# **2021 UMP Amendment**

**Olympic Regional  
Development Authority**

**SUBJECT:** Whiteface Mountain Intensive Use Area Unit Management Plan Amendment

**RESOLUTION ADOPTED BY THE ADIRONDACK PARK AGENCY  
WITH RESPECT TO THE  
WHITEFACE MOUNTAIN SKI CENTER INTENSIVE USE AREA UNIT  
MANAGEMENT PLAN AMENDMENT  
May 12, 2022**

**Figure 4: Whiteface Mountain Intensive Use Area  
Proposed Hiking Trails**

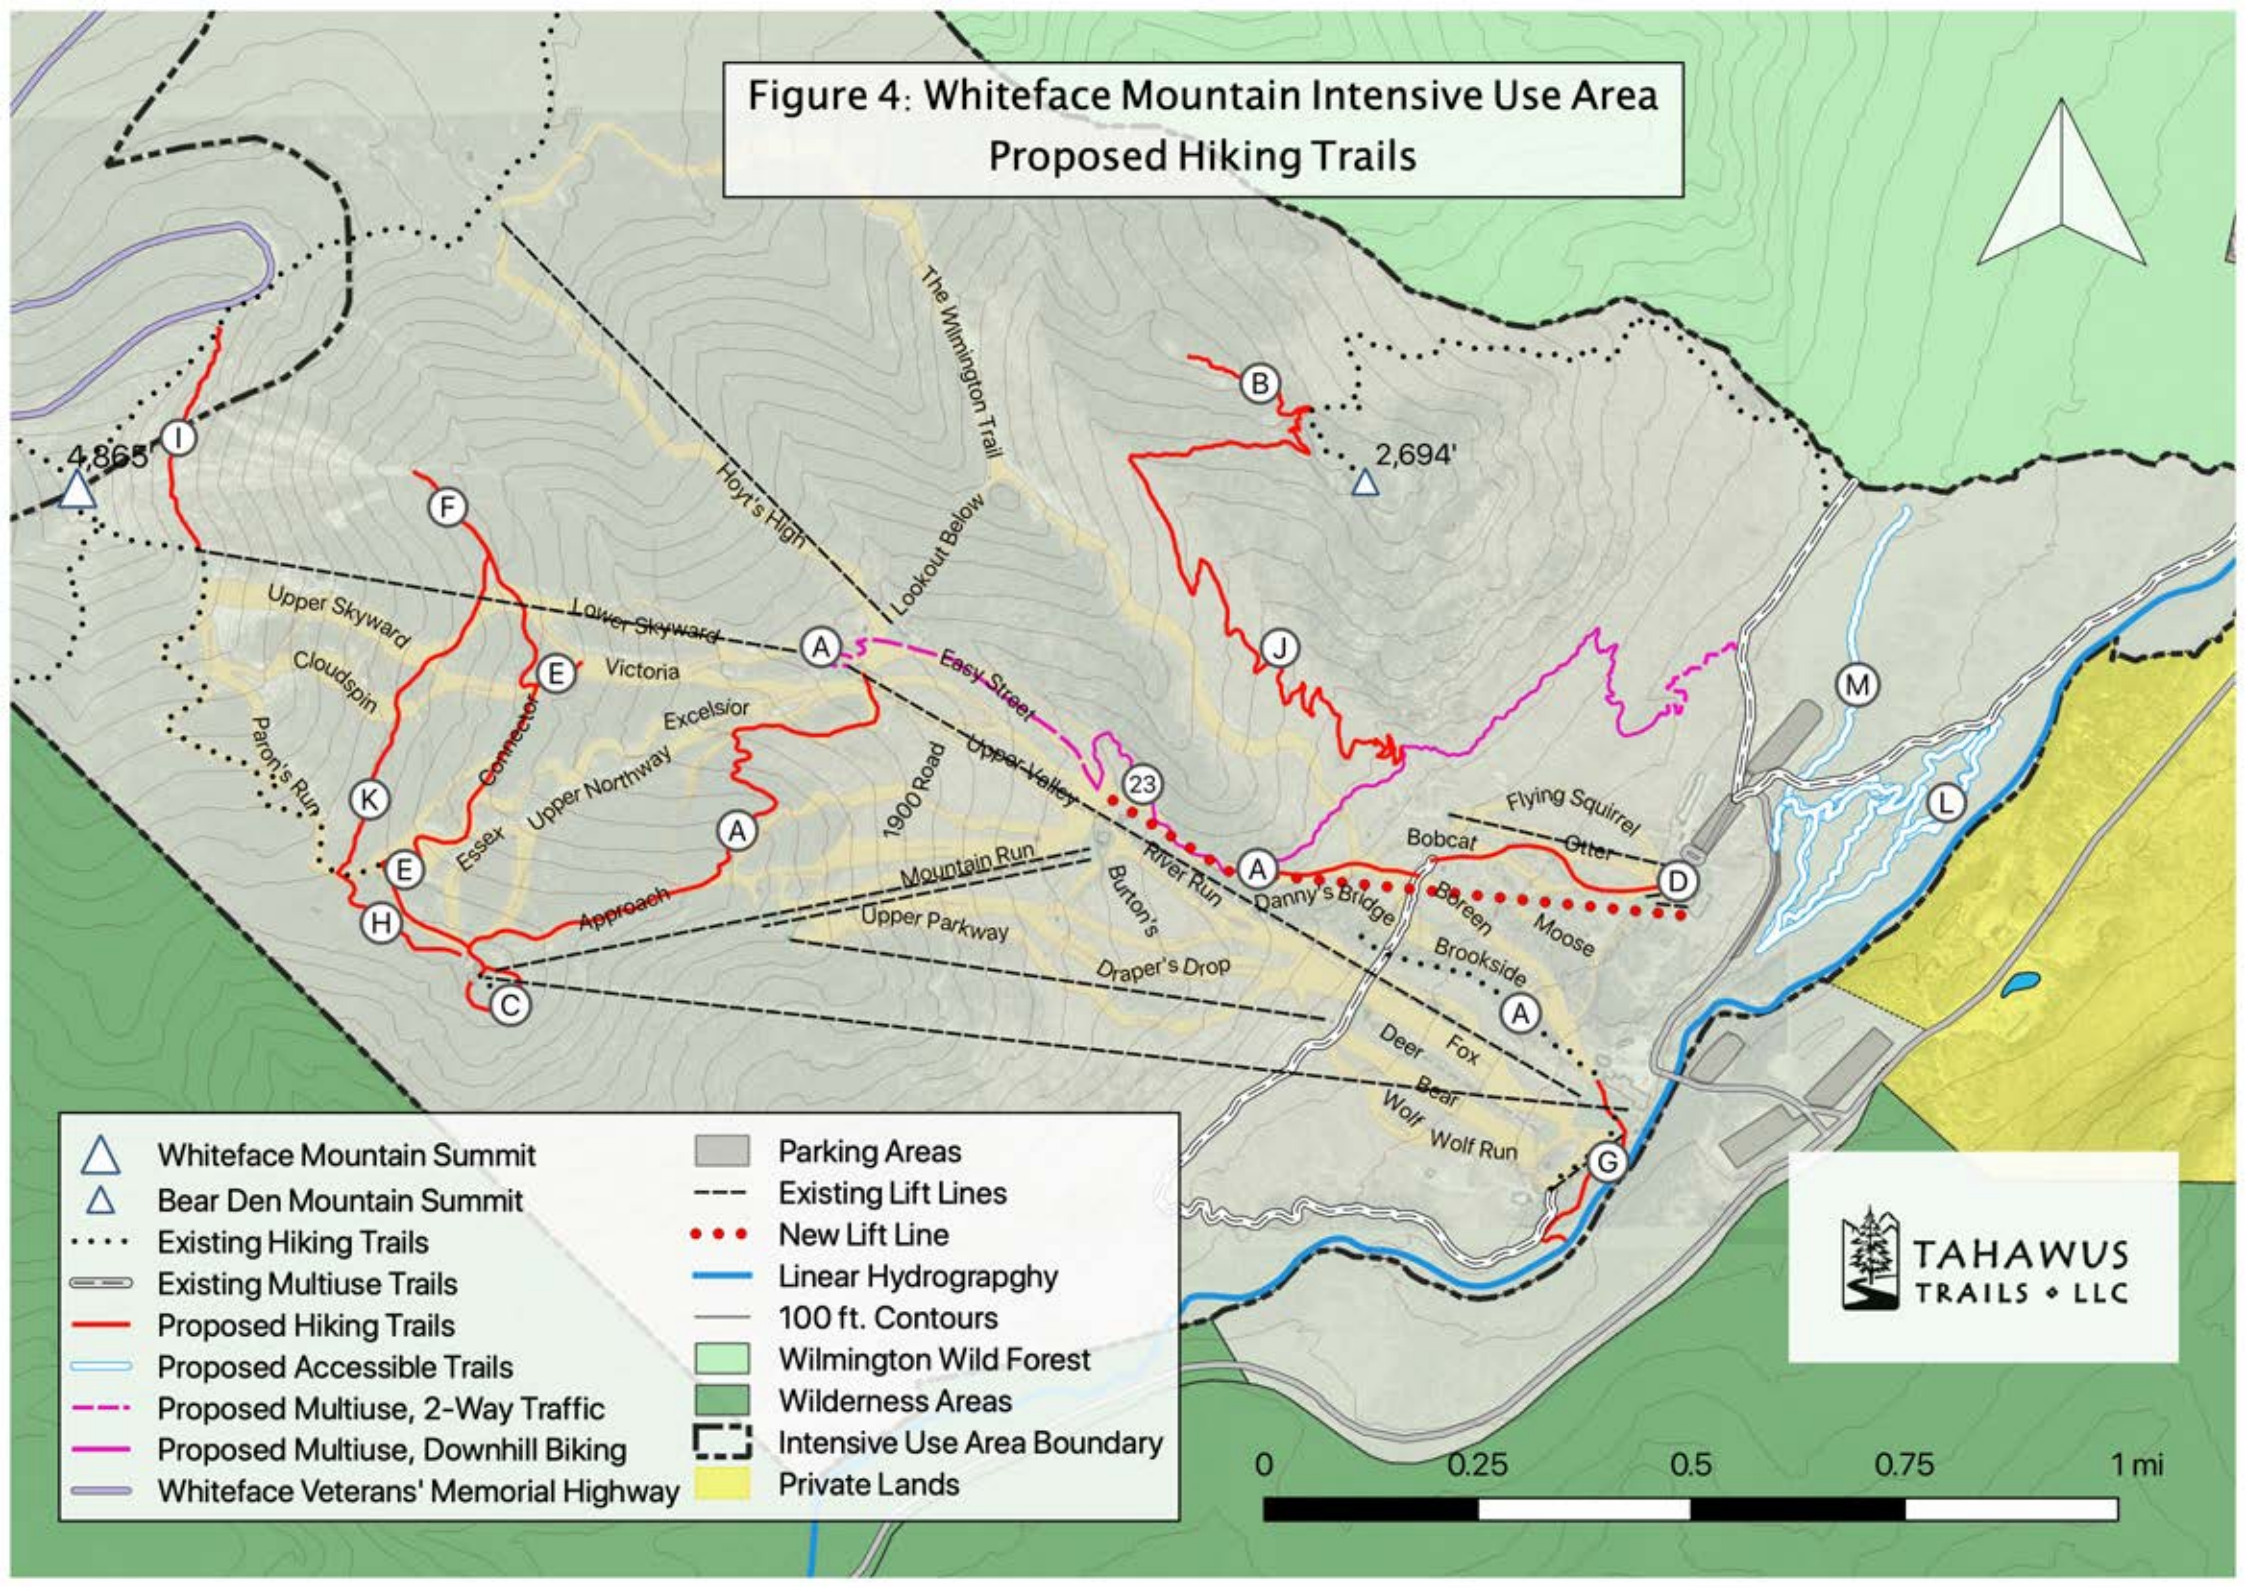
**Response:** Additional mountain biking is proposed in the Draft UMPA. However, the proposed mountain bike trails do not include access to the top of Little Whiteface, the summit of Whiteface or Lookout Mountain. A map of the proposed mountain bike trails is Figure 3 in Exhibit 3 of the Draft UMPA.

Drawing Title: **Potential Bicknell's Thrush Habitat and Proposed Actions**

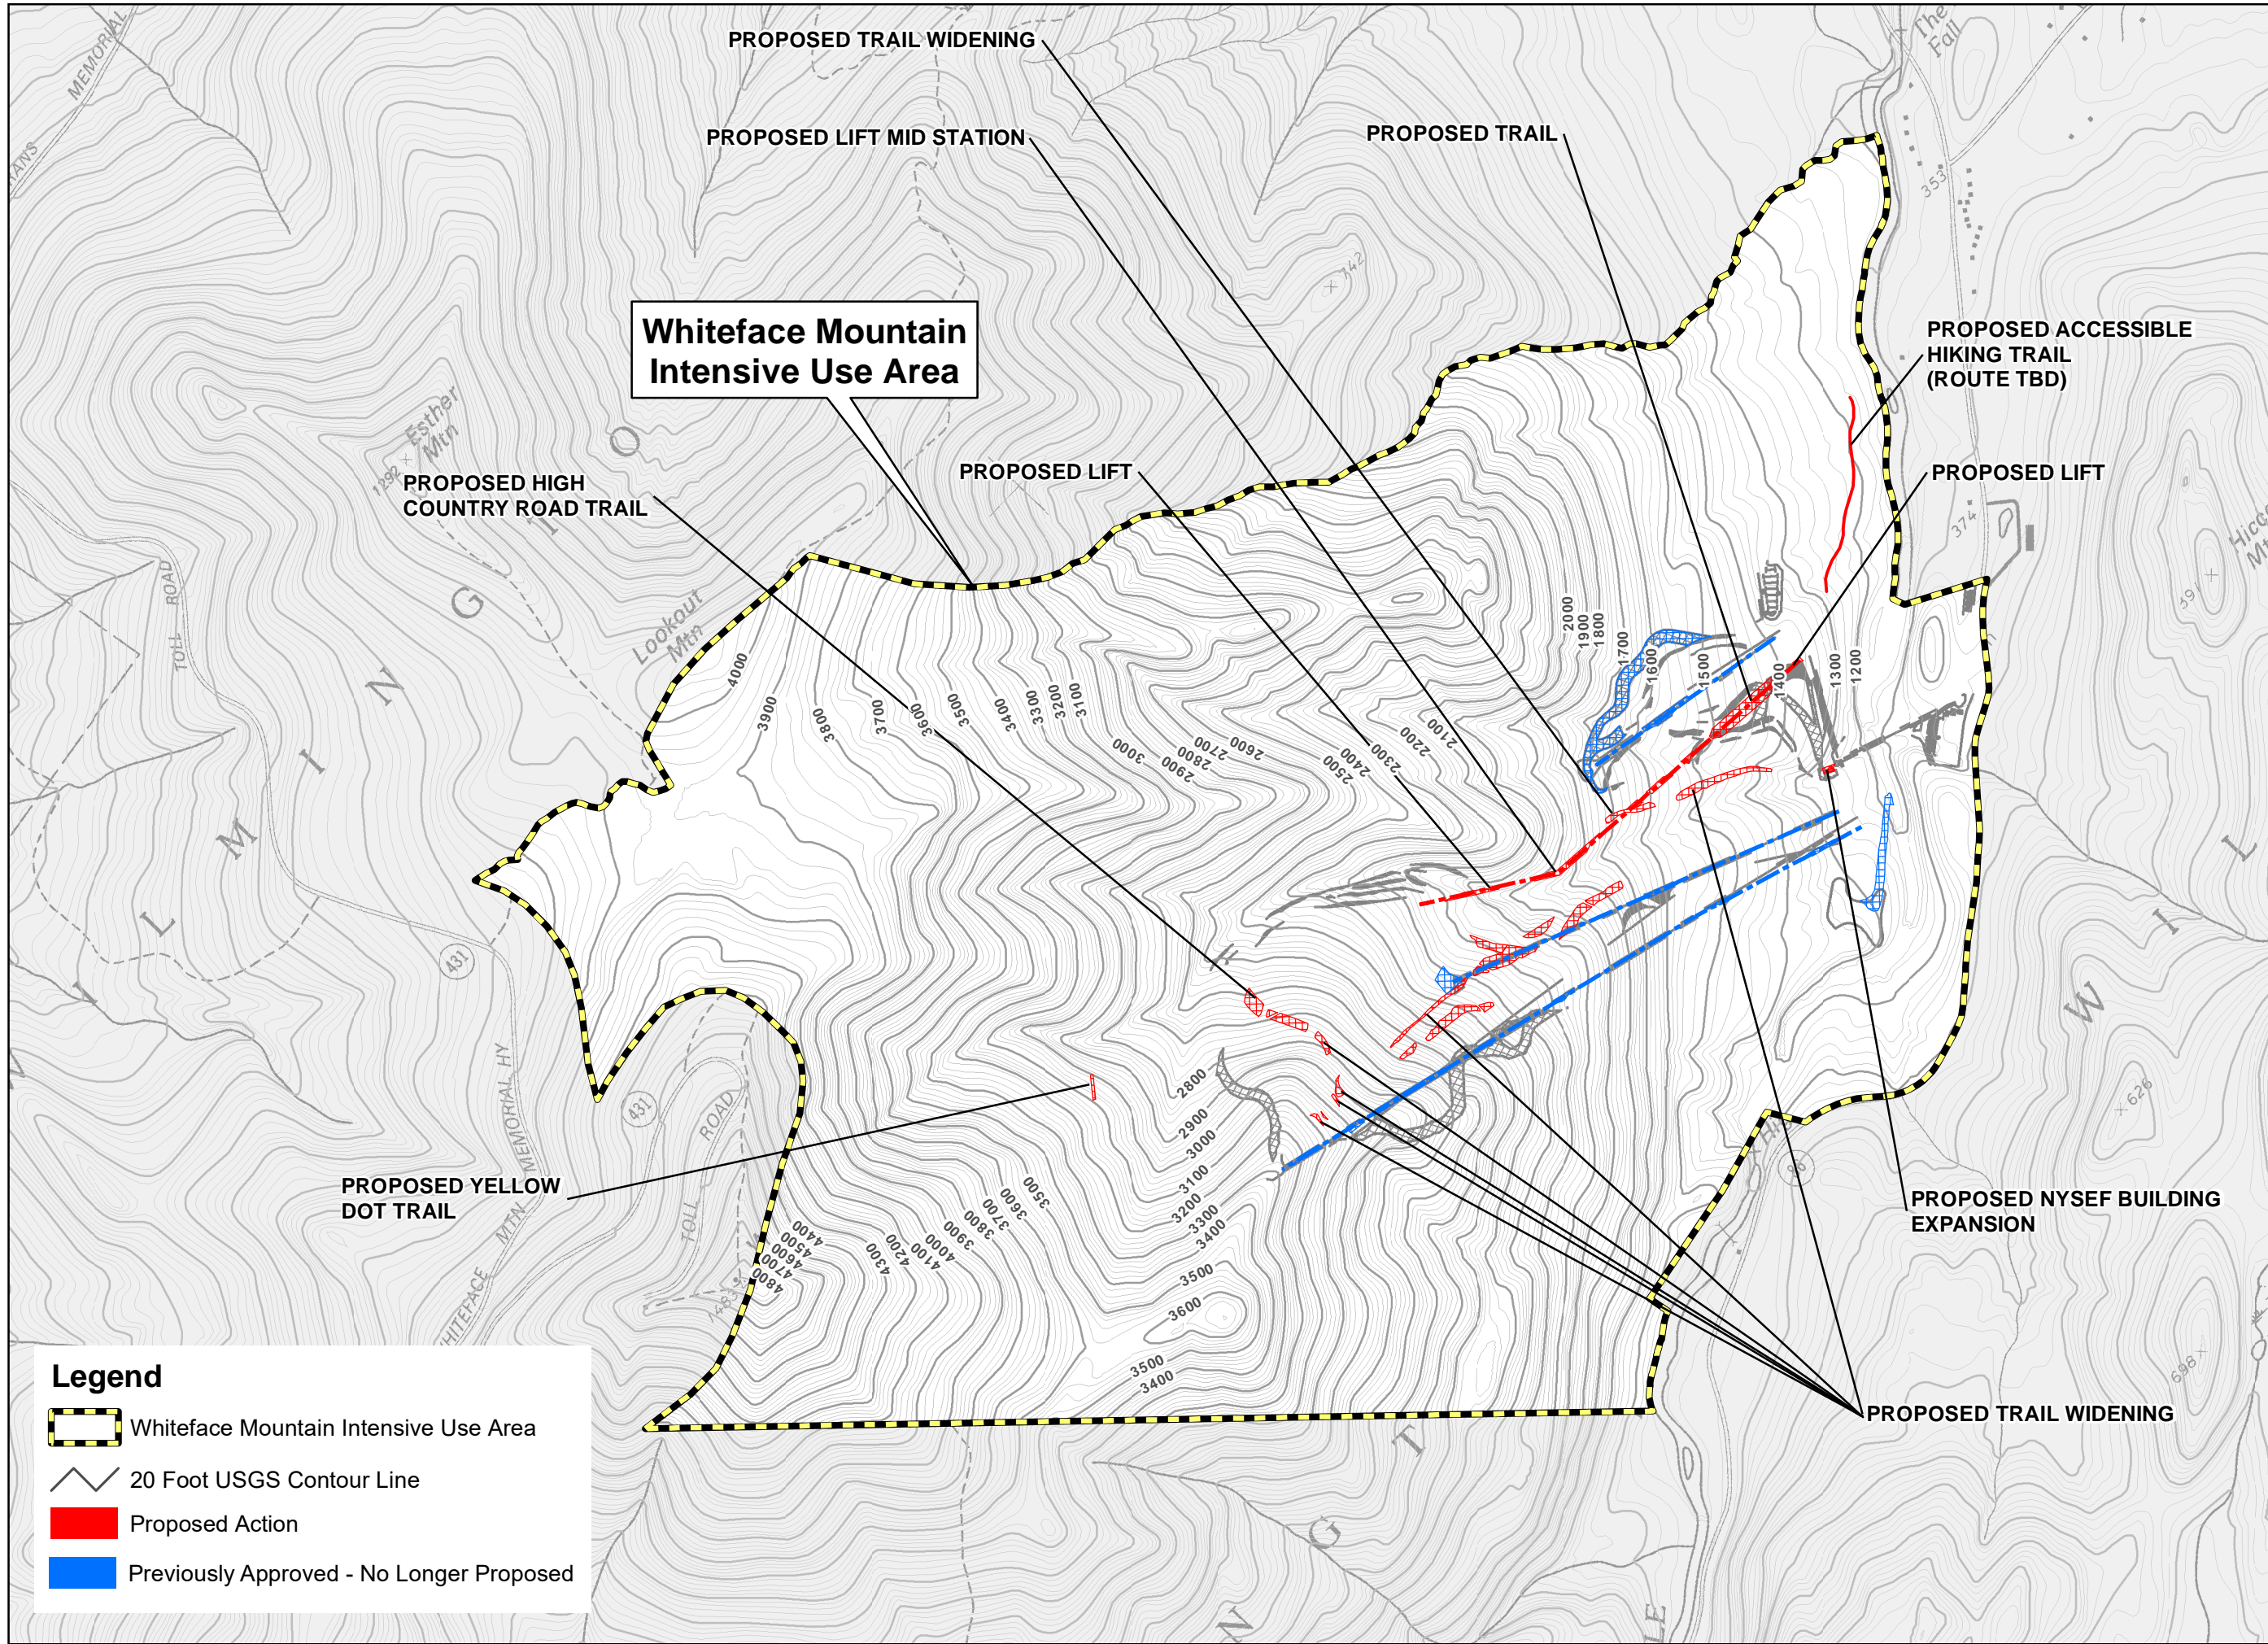
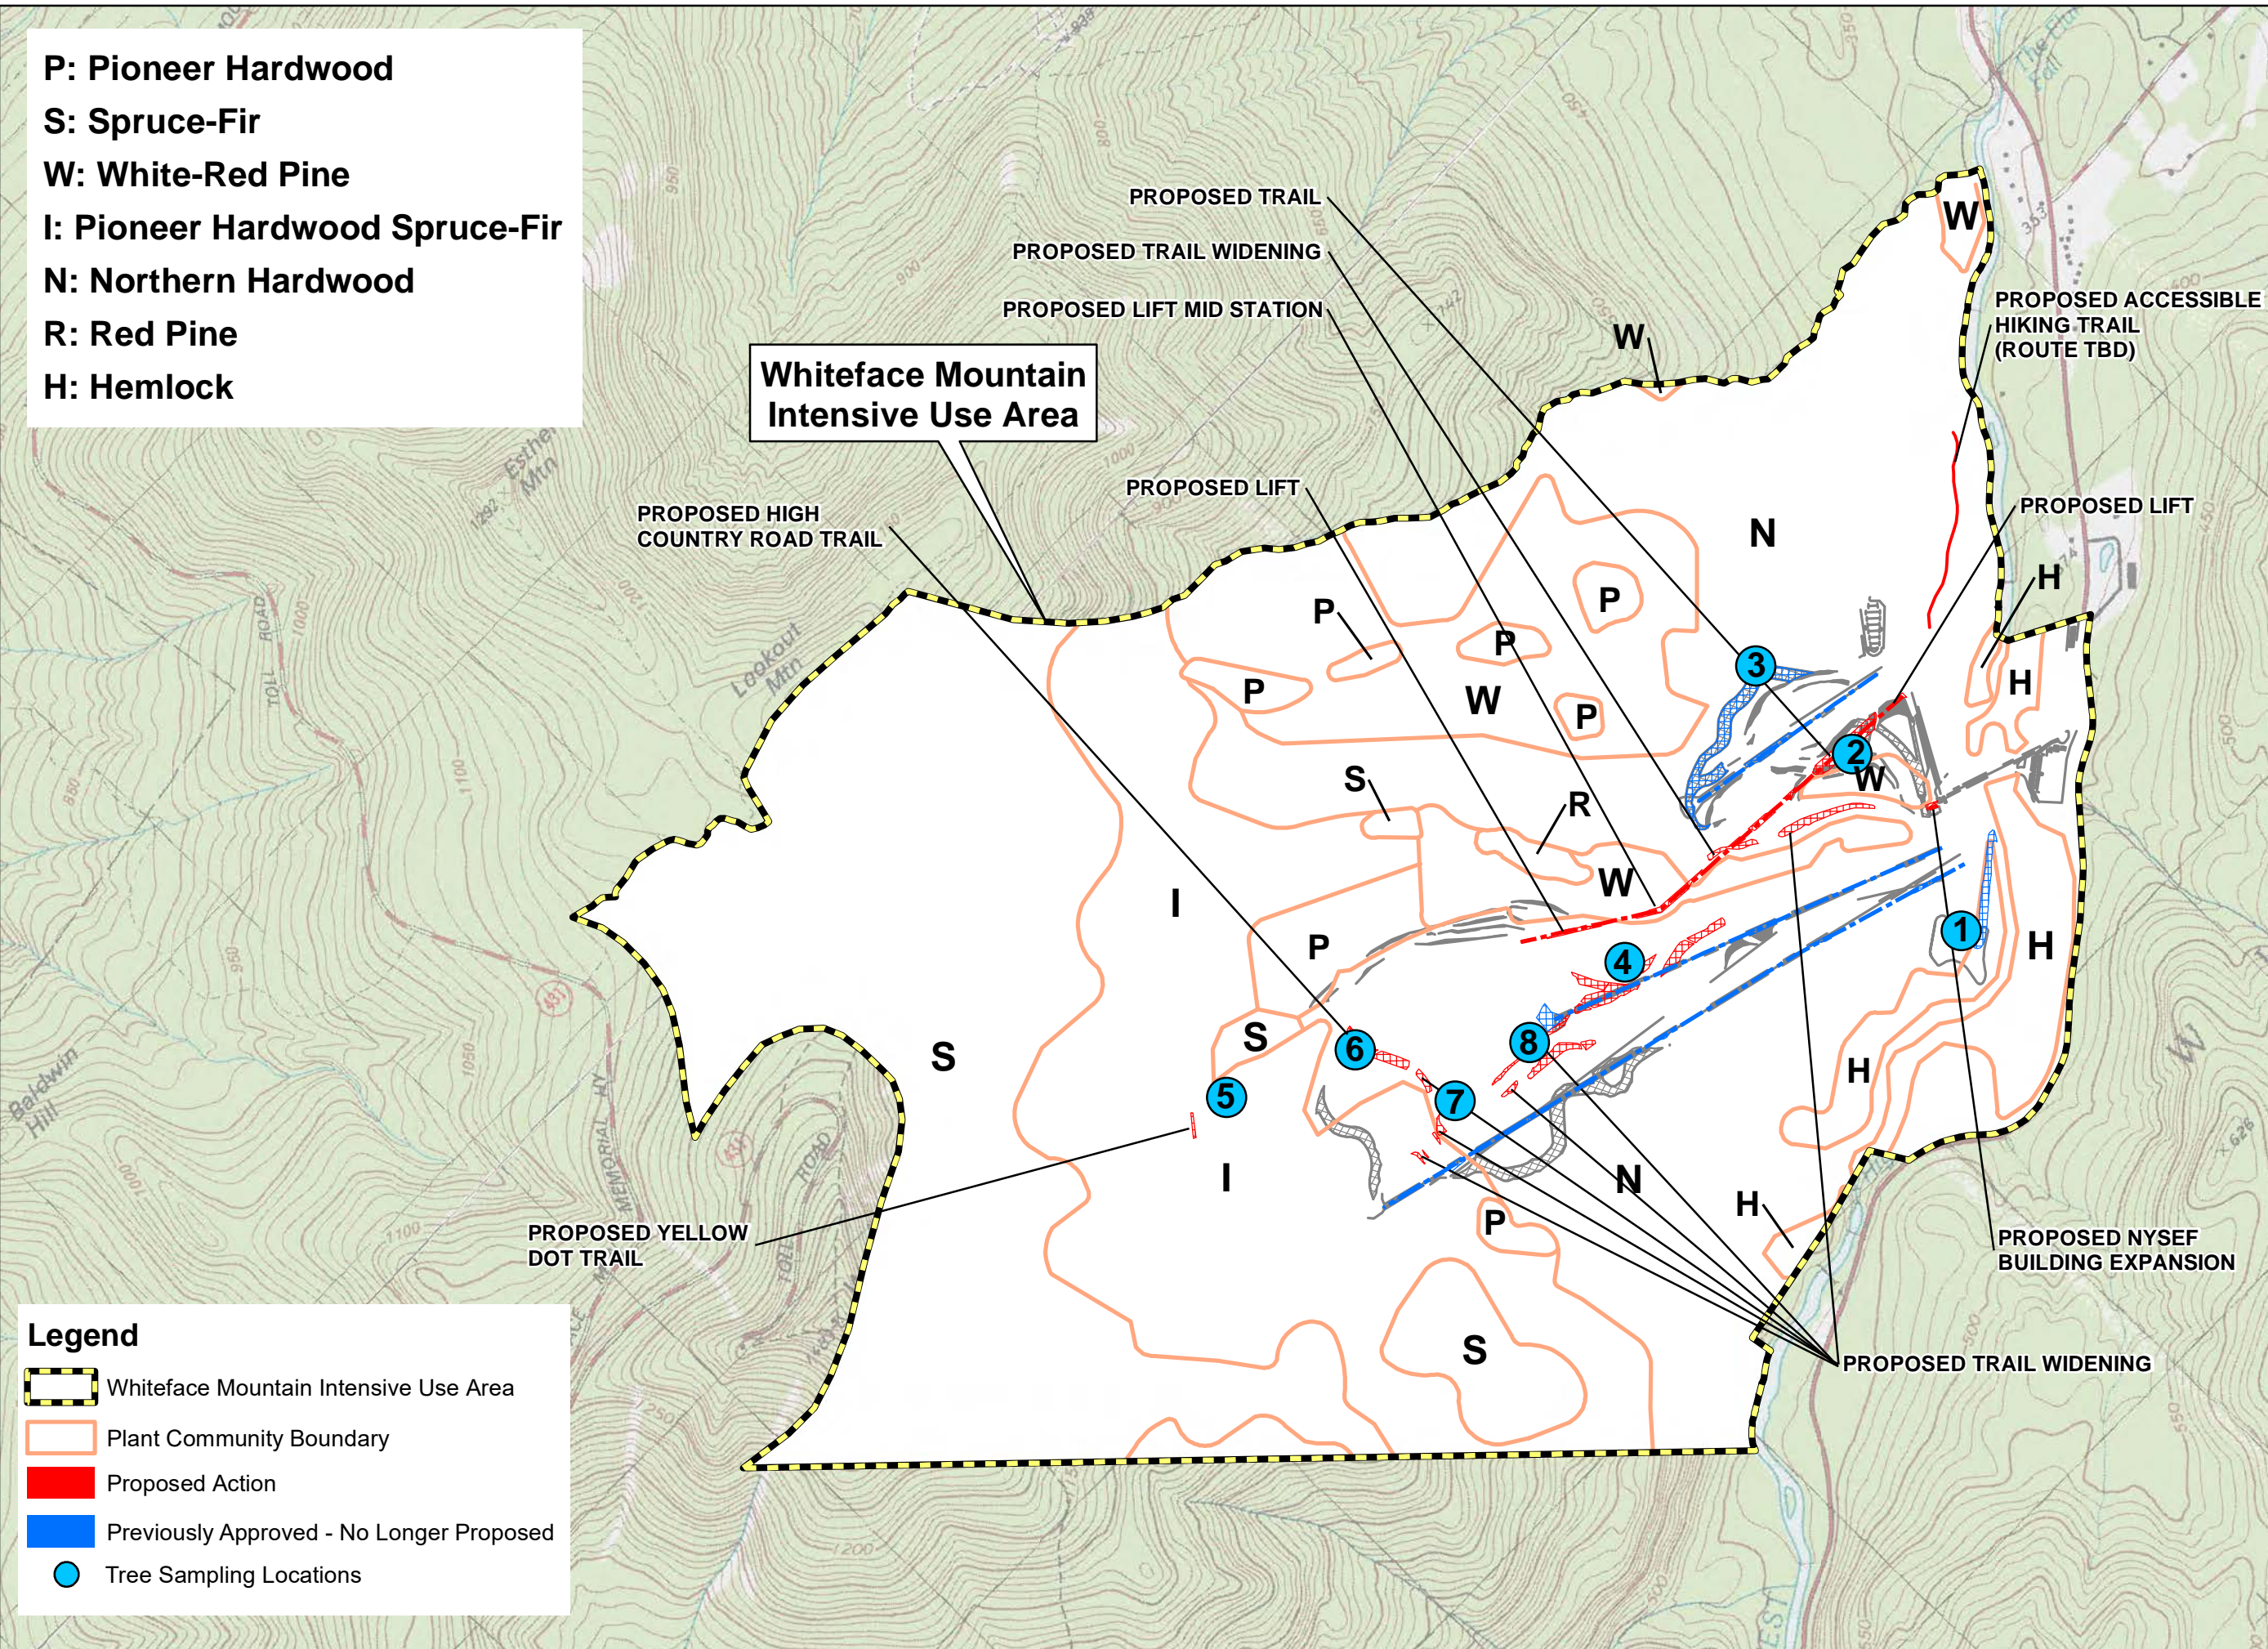
**Response:** See Figure 10 in the UMPA, *Potential Bicknell's Thrush Habitat and Proposed Actions*, showing ski area improvements in relation to the 2,800 foot elevation contour and the limits of spruce-fir habitat mapped on the Intensive Use Area. Also see figure 11 in the Draft UMP, *Potential Bicknell's Thrush Habitat and*

No ski area improvements are proposed in BITH habitat as shown on Figure 10. See UMPA section 3(G)(2).
